Date 10/11/2017
To Dominic Crinion
From Nathan Cairney (Tactical Group)
Copy to Steve Ryan (Tactical Group), Karen Harragon (DPE), Heather Nelson (DPE), Richard Johnson (Aspect Environmental), Michael Barrow (Qube), Westley Owers (Arcadis), Claire Vahtra (Arcadis)
Subject MPE Concept Plan Modification 2 – Consolidated assessment clarification responses

This memo and its attachments provides consolidates all information provided to the Department of Planning and Environment (DPE), since the submission of the MPE Concept Plan Modification 2 Response to Submissions (RtS) Report.

Moorebank Precinct East (MPE) Concept Plan Modification 2 (MP 10_0193 MOD 2)

Figure B-1 Historical contamination areas of environmental interest (Golders, 2013)

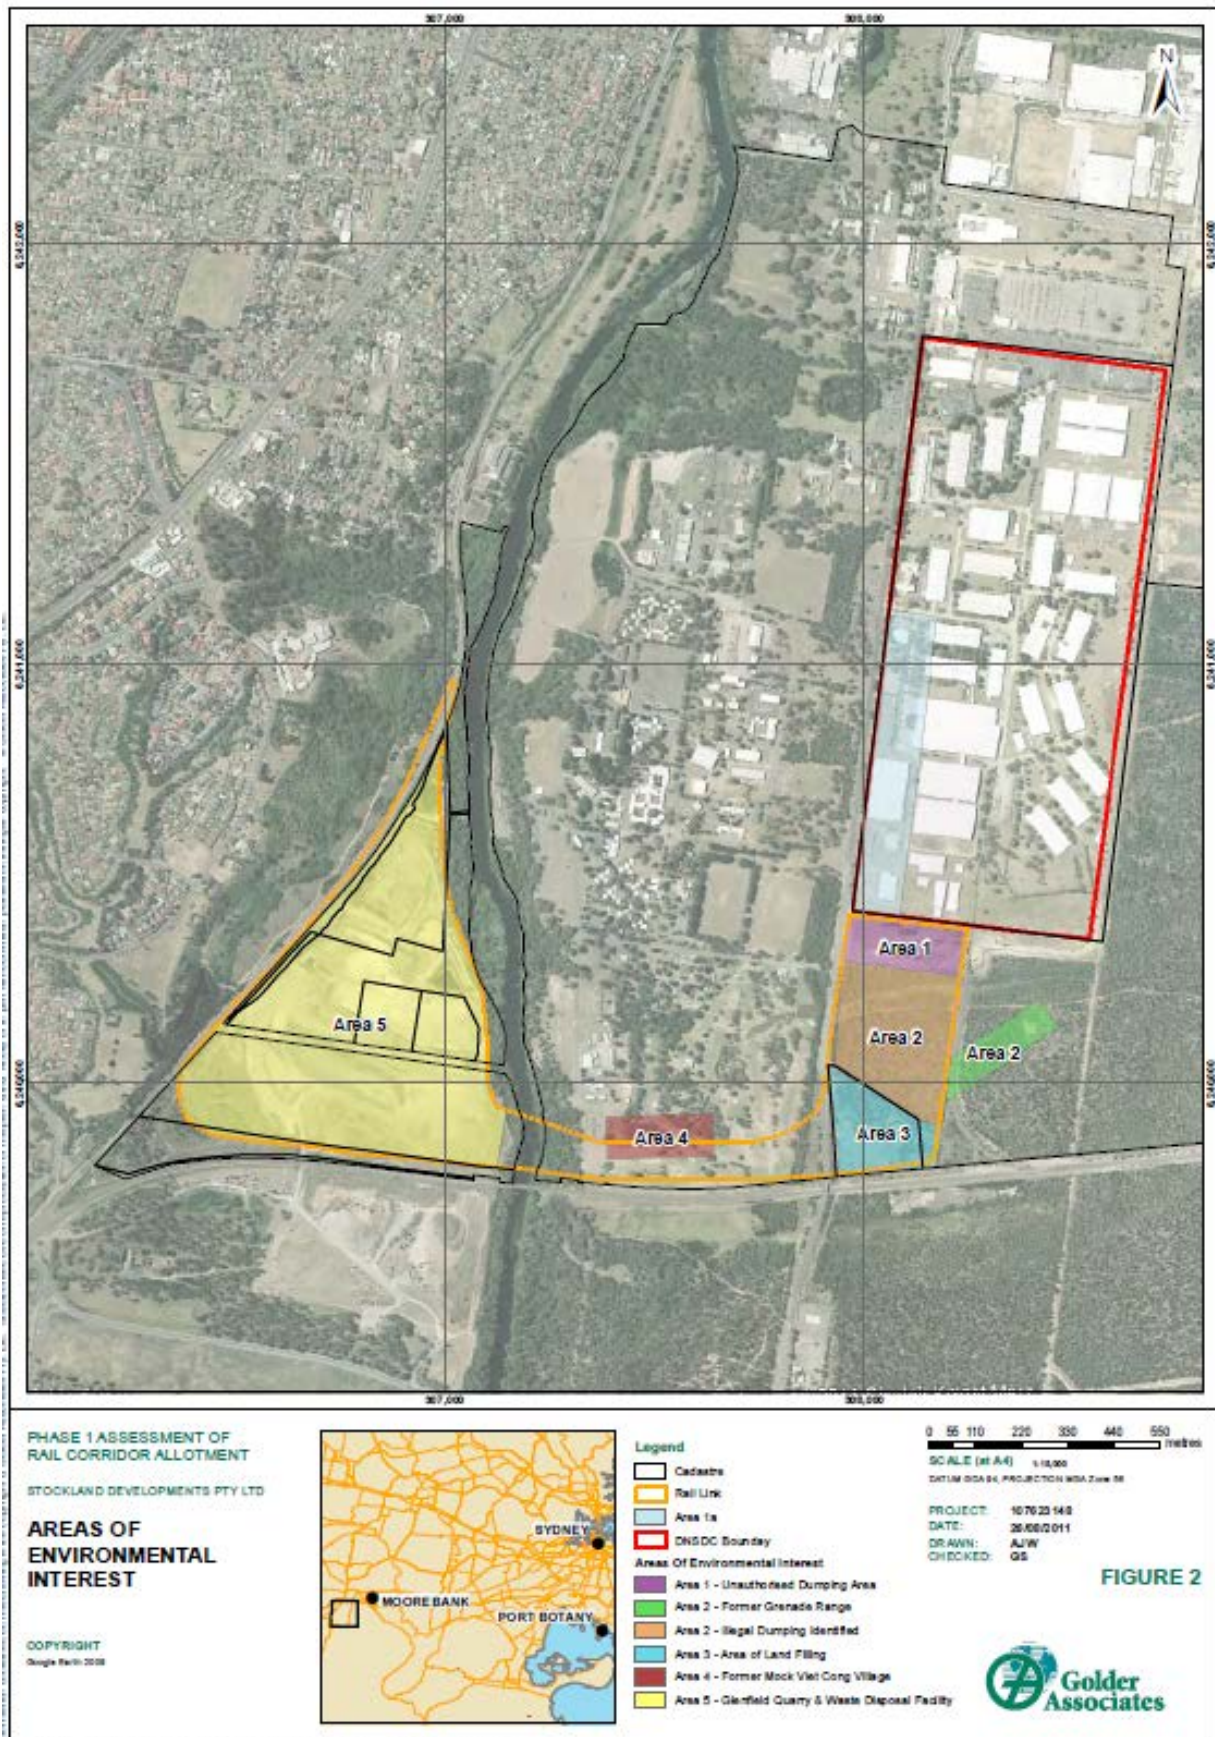
Soils (RtS ID LCC-31)	<p>It is considered that at a minimum the report should reference the location of the list of historical contamination investigations. Currently the Concept Plan Modification report provides little context regarding the extent of assessment.</p>	<p>The environmental assessment of contamination included in Section 5.5 of the MPE Concept Plan Modification 2 application is considered to be suitable to the extent required at the Concept Plan Approval Stage. The assessment undertaken for the Concept Plan Approval identified only areas of potential contamination concern within the location of the Rail corridor, i.e. outside of the MPE site. A summary of the information provided in the Concept Plan Approval EA is provided below:</p> <p>The Concept Plan Approval EA included the preparation of a Preliminary Environmental Site Assessment (ESA) (Golder, 2011). Five areas within or near the MPE Project site were identified as part of the Preliminary ESA as having the potential to contain subsurface contamination, however each of these areas are predominately outside of the MPE site. These five areas include:</p> <ul style="list-style-type: none"> Area 1 – located immediately south of the MPE site. Historic information suggests that partially remediated areas of unauthorised dumping may have occurred. 	<p>Concept Plan Approval EA included the preparation of a Preliminary Environmental Site Assessment (ESA) (Golder, 2011)</p> <p>Section 5.5 of the MPE Concept Plan Modification 2 application</p>

Aspect	Issue	Response	Reference
		<ul style="list-style-type: none"> Area 2 – comprising the bushland area south of the MPE site. Historic information indicates that potential unexploded ordinance (UXO) associated with a former grenade range may be present. This area also showed evidence of previous illegal dumping. Area 3 – Lot 1 DP825352 owned by Sydney Trains has been subject to extensive filling with the area levelled approximately two to 2.5 metres higher than surrounding areas. Area 4 – comprising the south-west portion of the golf course was historically used as part of a mock Viet Cong village. Although the village has been demolished, there is potential tunnel materials buried in the area. Area 5 – comprising the Glenfield Quarry and Waste Disposal Facility is located south-west of the MPE Site. Extractive and waste disposal activities currently take place at this location in accordance with an EPL. This land is also subject to an ongoing maintenance order. <p>Attachment B provides the location of the above historical investigations (areas as discussed above). Note that this information has since been updated by the MPE Stage 1 (SSD 14-6766) contamination investigations.</p> <p>More detailed contamination information is provided as part of the staged applications as they include physical works. No further information is therefore considered necessary for the Concept Plan Approval.</p>	Attachment B
